[A-MAP relevance and HARQ timing for long TTI transmission (Section 15.3.9.2.2)]

IEEE C802.16m-09/1923

A-MAP Relevance and HARQ Timing for Long TTI Transmission (Section 15.3.9.2.2)

Current HARQ Feedback Timing

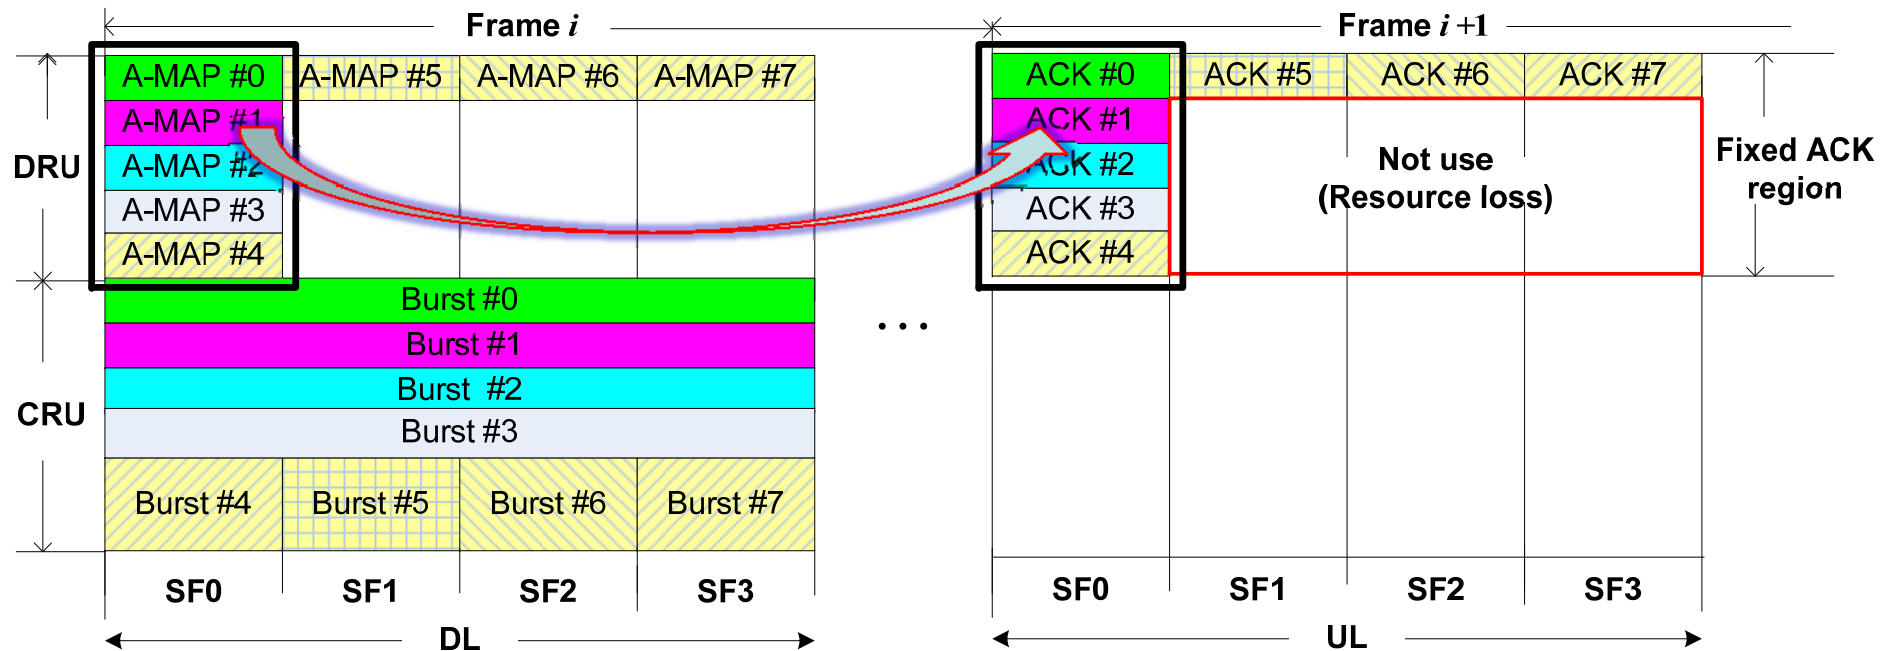
Current A-MAP Relevance

- The transmission of the A-MAPs for long TTI burst are concentrated in a certain subframe as 0th subframe (SF0)

- A-MAP region in 0th subframe become larger and larger according to number of long TTI bursts → large DRU regions are needed for A-MAP → limit to CRU region

- HARQ feedback corresponding long TTI burst shall be transmitted in 0th UL subframe

Proposed A-MAP Relevance

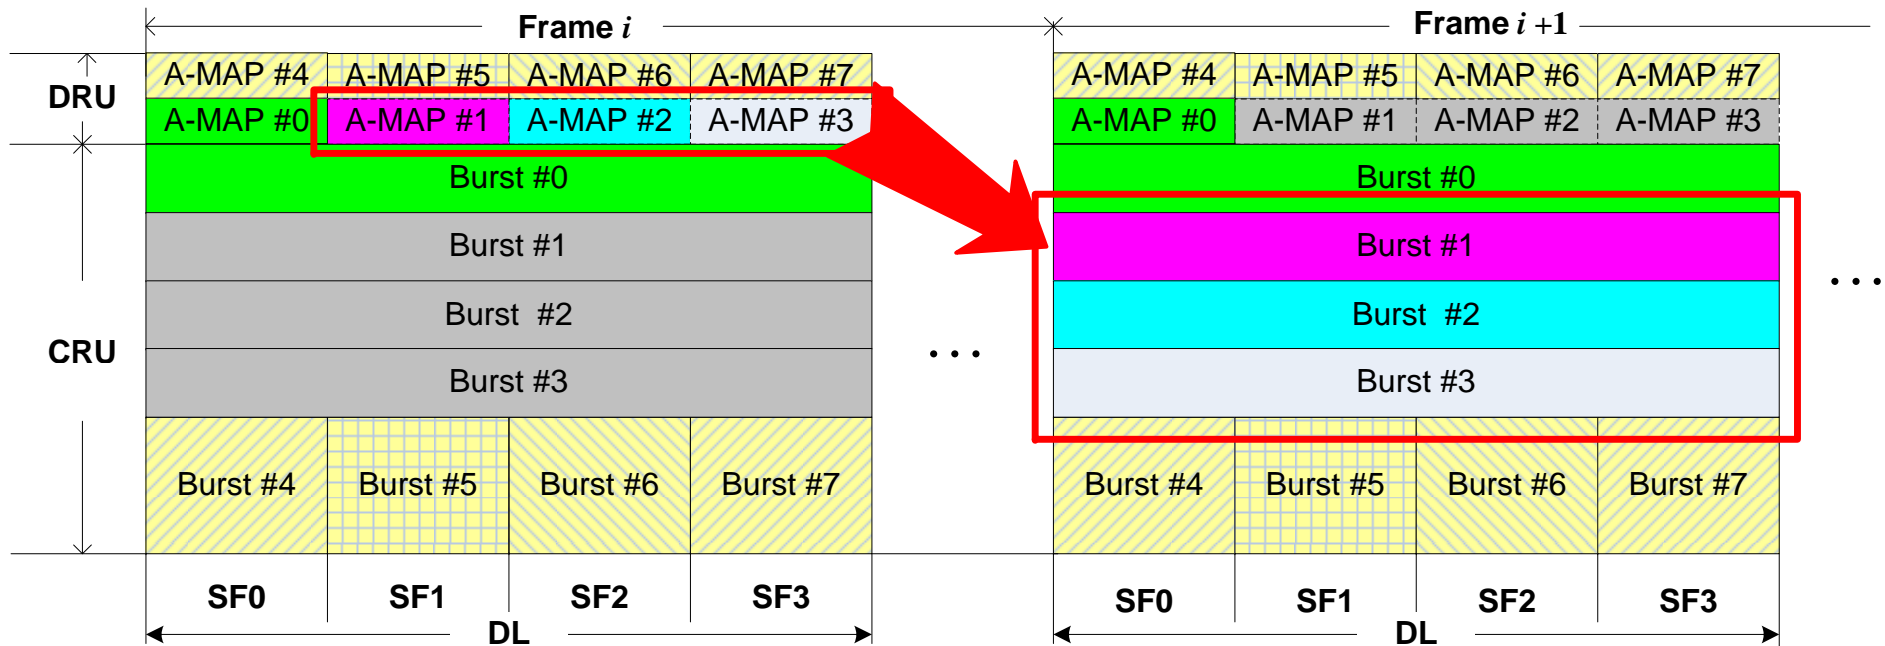
- Long TTI transmission begins in 0th subframe of next frame when DL subframes (except 0th) contains the A-MAPs indicating long TTI

Proposed HARQ Feedback Timing

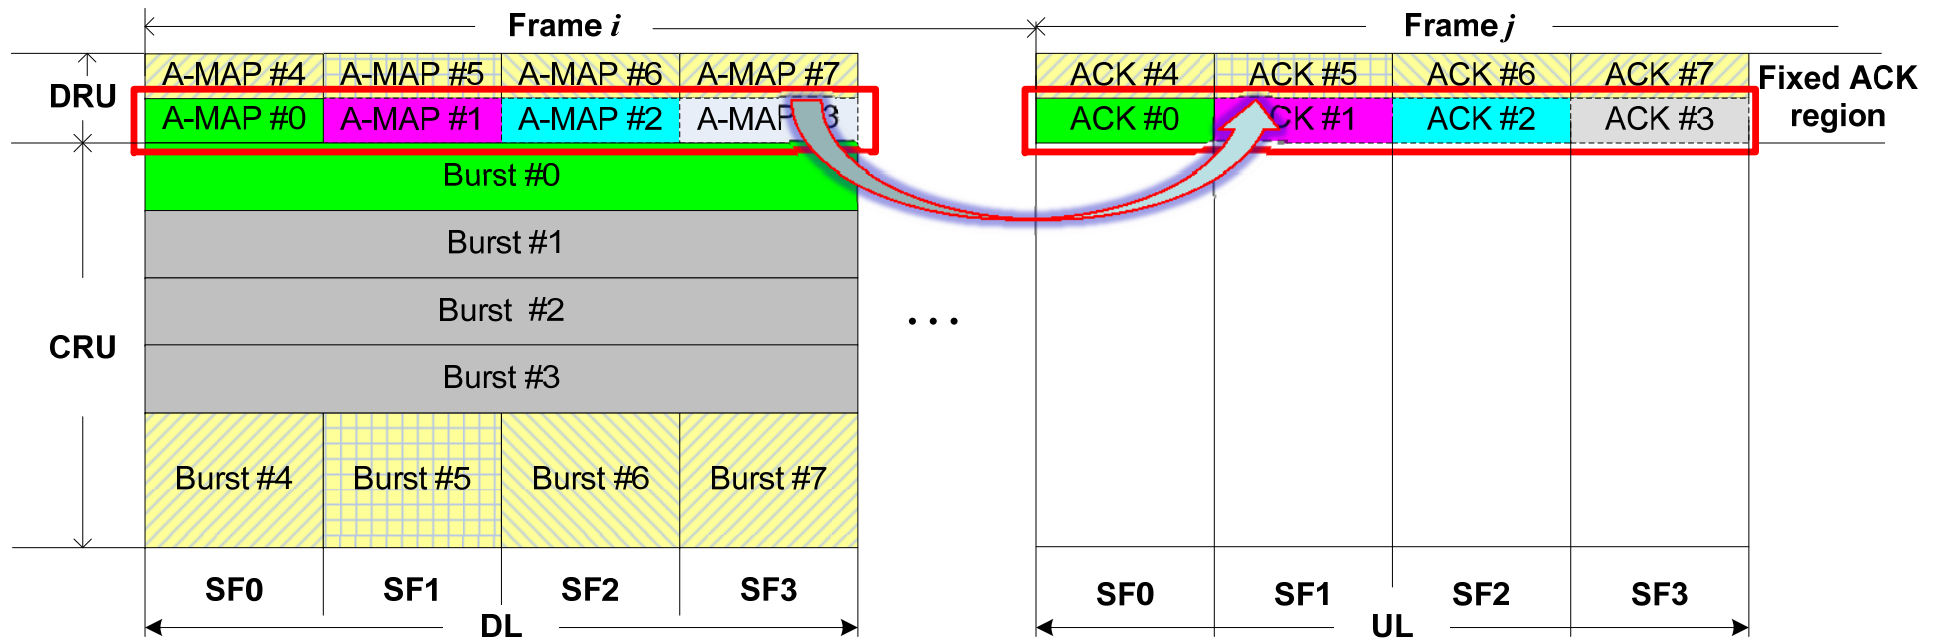
- HARQ feedback corresponding long TTI burst is transmitted in the UL subframe corresponding DL subframe index contains the burst's A-MAP

- DL long TTI (e.g. $T_{proc} = 3$ subframes)

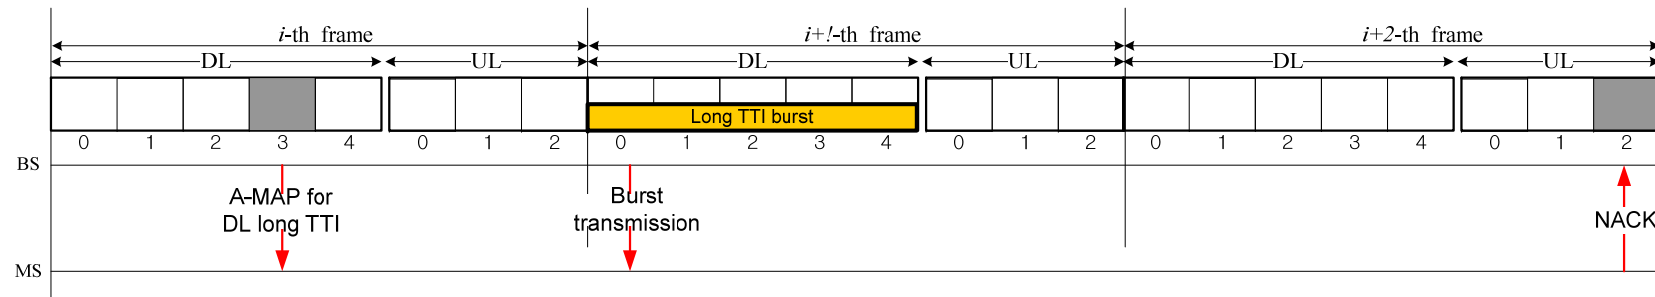
Examples of Proposed Timing
